Rezoning Application: PD 25-1387

Development Services Department

APPLICATION NUMBER: PD 25-1387

AGENCY REVIEW COMMENT SHEET

8.0 PROPOSED SITE PLAN (FULL)

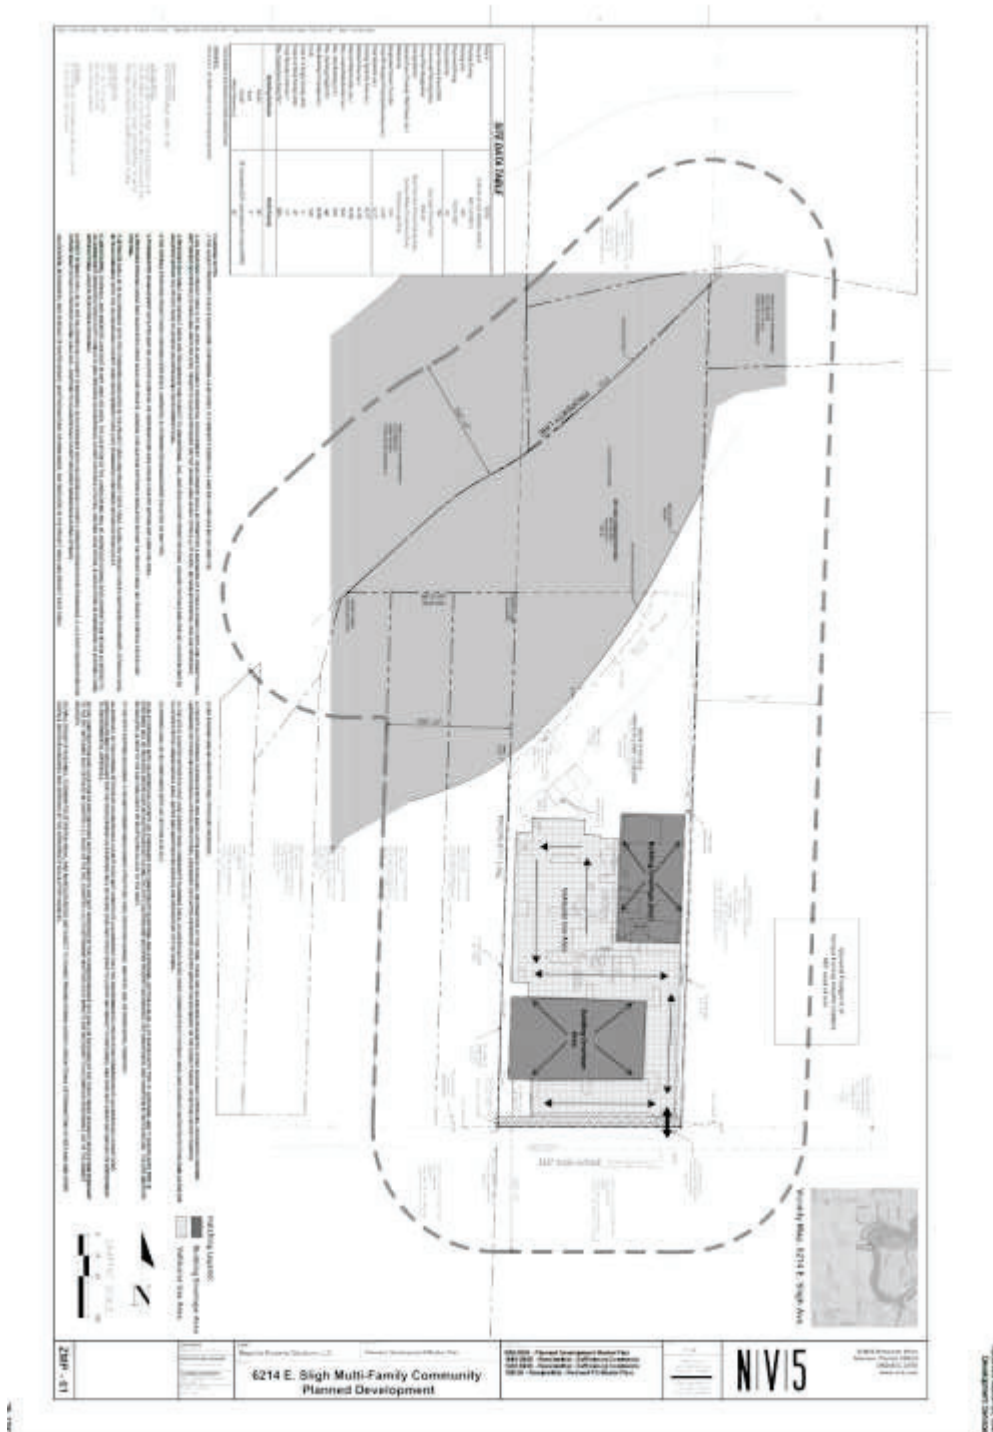
- Prior to site plan certification, the PD Site Plan shall be revised to change the right of way preservation label to state; “+/- 12.5 Feet of Right-of-Way Preservation per Hillsborough County Corridor Preservation Plan.”

- Prior to site plan certification, the PD Site Plan shall be revised to change the right of way preservation label to state; “+/- 12.5 Feet of Right-of-Way Preservation per Hillsborough County Corridor Preservation Plan.”

DRIVEWAY SPACING

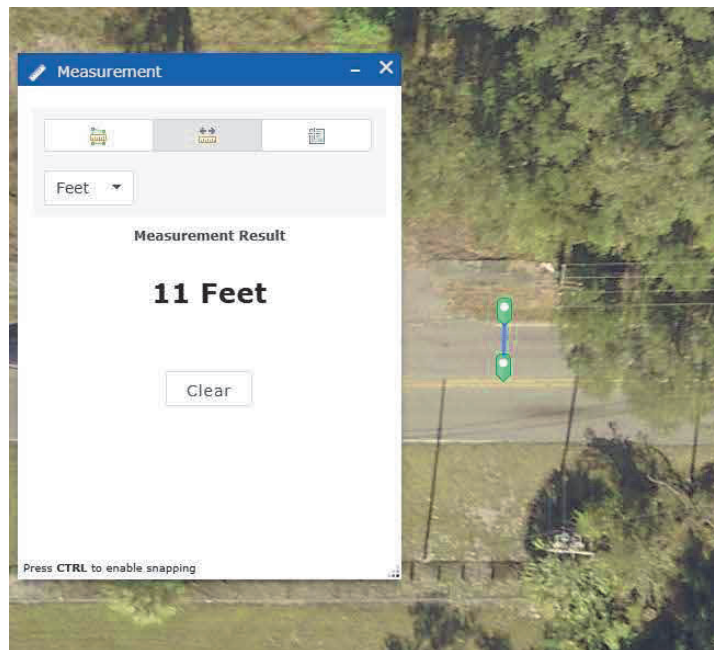
The applicant's EOR submitted a Section 6.04.02.B. Administrative Variance Request (dated February 5, 2026) from the Section 6.04.07. LDC requirement governing access spacing. Per the LDC, Sligh Ave is a Class 6 roadway, which requires minimum connection spacing of 245 feet. The applicant is seeking the following variances relative to its project's proposed access connection on Sligh Ave:

- A variance of +/- 187 feet, resulting in access spacing of +/- 53 feet from the next closest driveway to the east (on the same side of the roadway), and
- A variance of +/- 42 feet, resulting in access spacing of +/- 203 feet from the next closest driveway to the west (on the same side of the roadway), and
- A variance of +/- 165 feet, resulting in an access spacing of +/- 80 feet from the eastern portion of the driveway serving folio 40162.0000 on the south side of the roadway.

Based on factors presented in the Administrative Variance Request, the County Engineer found the request approvable subject to conditions (on March 9, 2026). If PD 25-1387 is approved, the County Engineer will approve the above referenced Administrative Variance request.

LANE MEASUREMENT - 11 FT

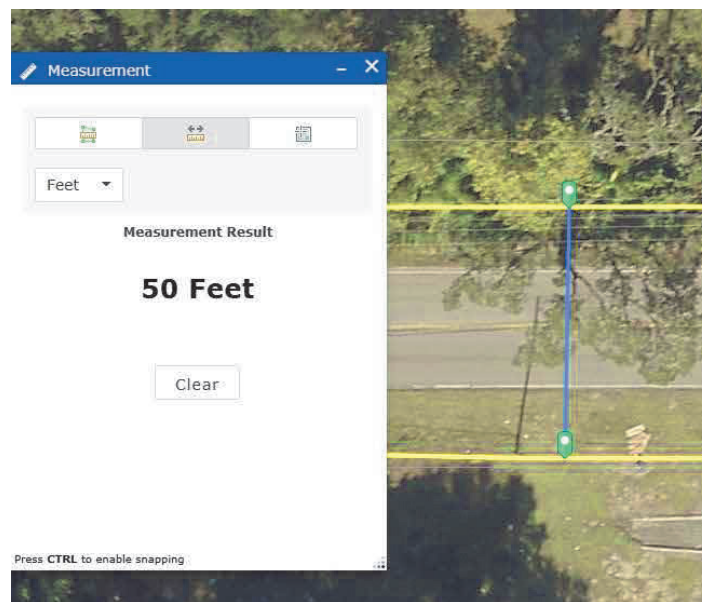
Given that Sligh Ave is a substandard collector roadway, the applicant's Engineer of Record (EOR) submitted a Design Exception request (dated February 20, 2026) to determine the specific improvements that would be required by the County Engineer. Based on factors presented in the Design Exception Request, the County Engineer found the Design Exception approvable (on March 9, 2026) authorizing deviations from the Transportation Technical Manual (TTM) Type TS-4 Typical Section (for 2-lane, Undivided Collector Urban Roads) including:

- The developer shall be permitted to preserve the 11-foot-wide travel lanes; and,
- The developer shall not be required to install bike lanes; and,
- The developer shall construct a 5-foot-wide sidewalk on the north side of Sligh Ave connecting the existing sidewalk at the pedestrian gate for folio 38590.1000 (Society Dr) to Halifax River Dr (folio 38588.5100) totaling approximately 1,016 linear feet.

If 25-1387 is approved by the Hillsborough County Board of County Commissioners (BOCC), the County Engineer will approve the above-referenced Design Exception.
